Preliminary Plat Request for Kraewood Addition

CITY COUNCIL

OCTOBER 19, 2021

MIKAYLA SCHMIDT, CITY PLANNER

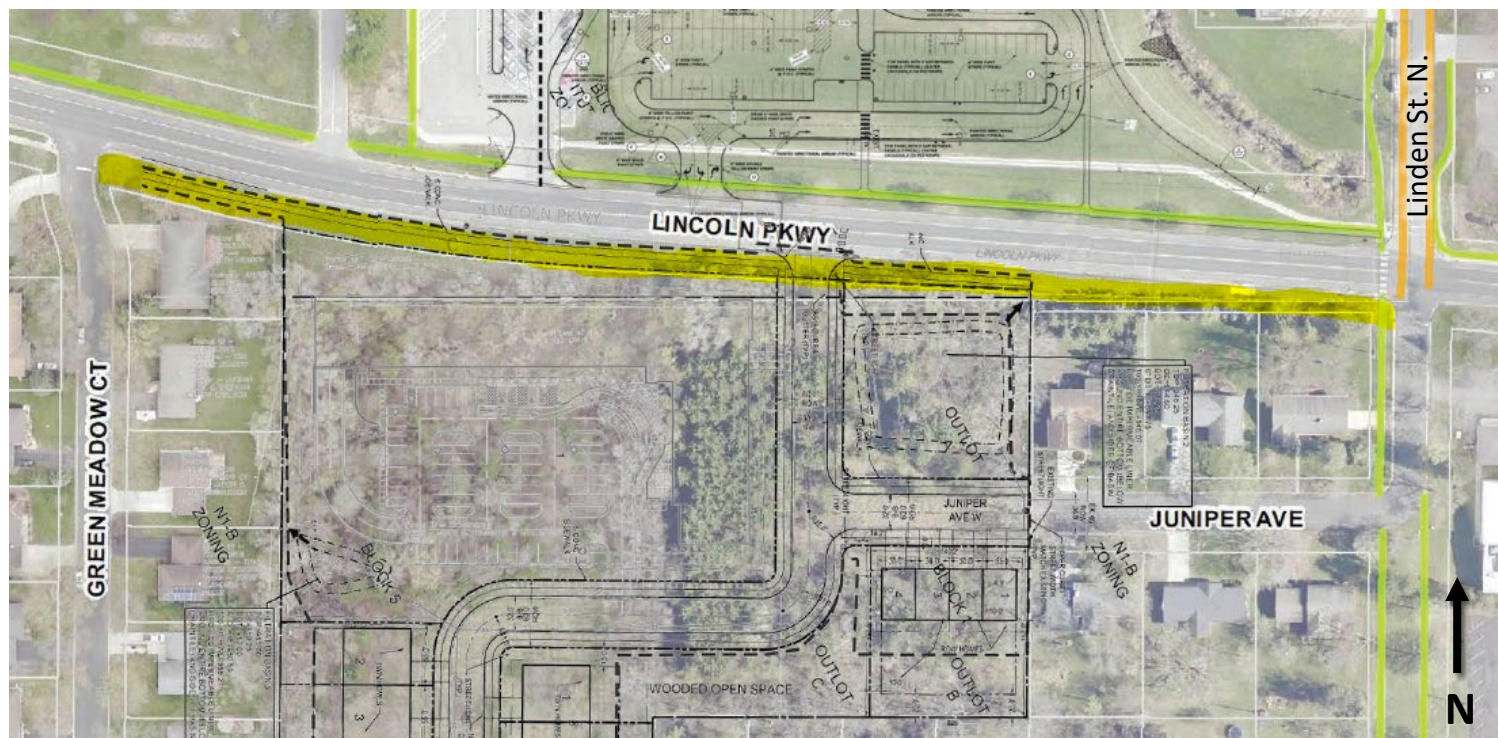
7. Create a non-motorized multi-model connection from Kraewood Dr. to Ivanhoe Ave.

Staff recommends making a connection from Kraewood Dr. to Ivanhoe Ave.

There is an existing easement on the west end of Ivanhoe Ave. specifically for emergency access of vehicles for fire, police, etc. The applicant is willing to add this connection to extend to the emergency access easement from Ivanhoe Ave. to Kraewood Dr.

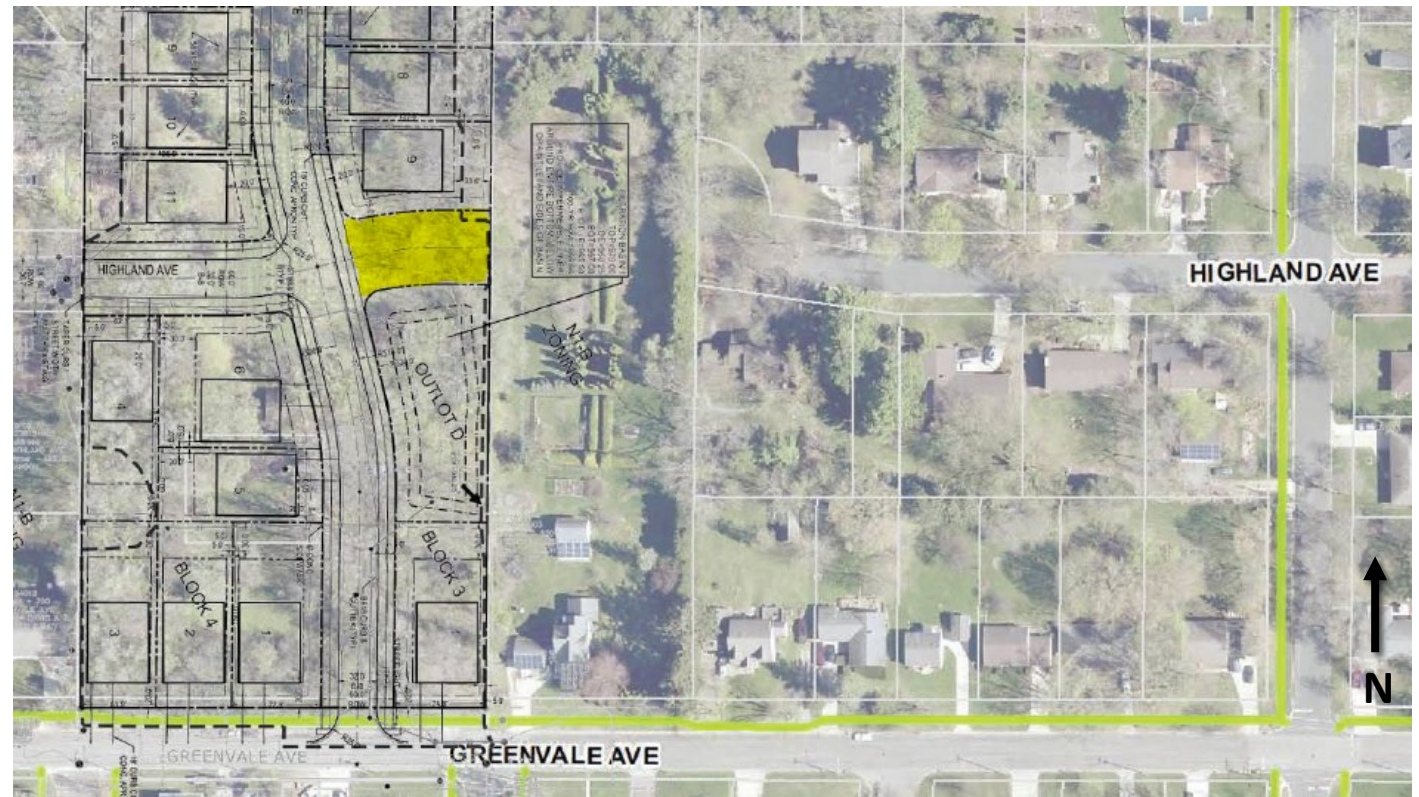
1. A 6-foot sidewalk shall be constructed on the south side of Lincoln Parkway from Green Meadow Court to Linden Street North by the Applicant and shown in the Final Plat.

2. Highland Avenue shall be fully constructed (i.e. utilities, grading, pavement and curb installed) to the east of Kraewood Dr. to within 20 feet of the east property line as determined by the City Engineer and shown in the Final Plat.

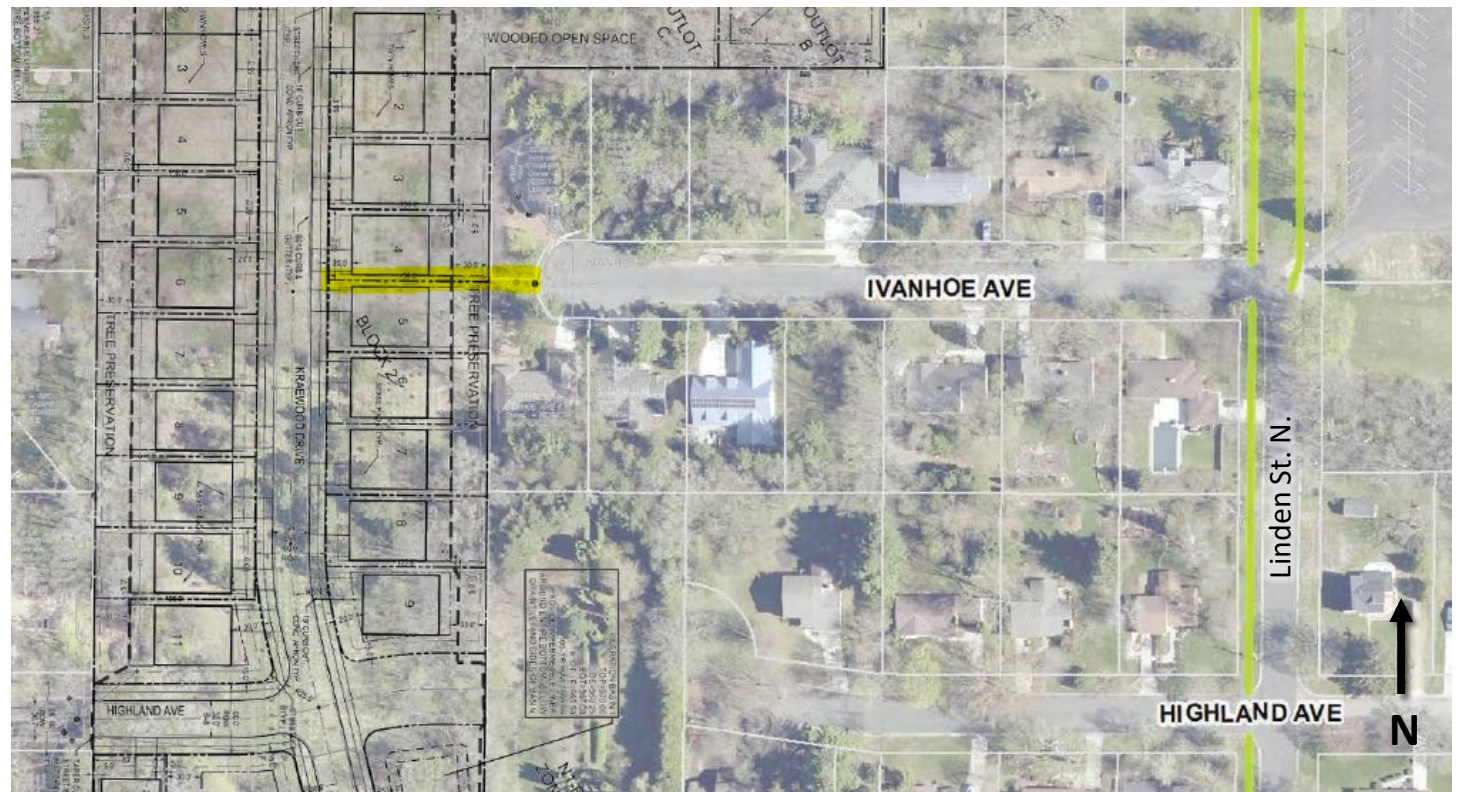
7. The Applicant shall meet the park dedication requirements in City Code, Chapter 34, Section 5.2.6 in the form of cash-in-lieu for parks and open space acquisition and development.

6. A 20-foot access for ingress/egress for emergency vehicles shall be shown on the final plat and the same shall be created and installed by the Applicant that connects Ivanhoe Drive to Kraewood Drive.
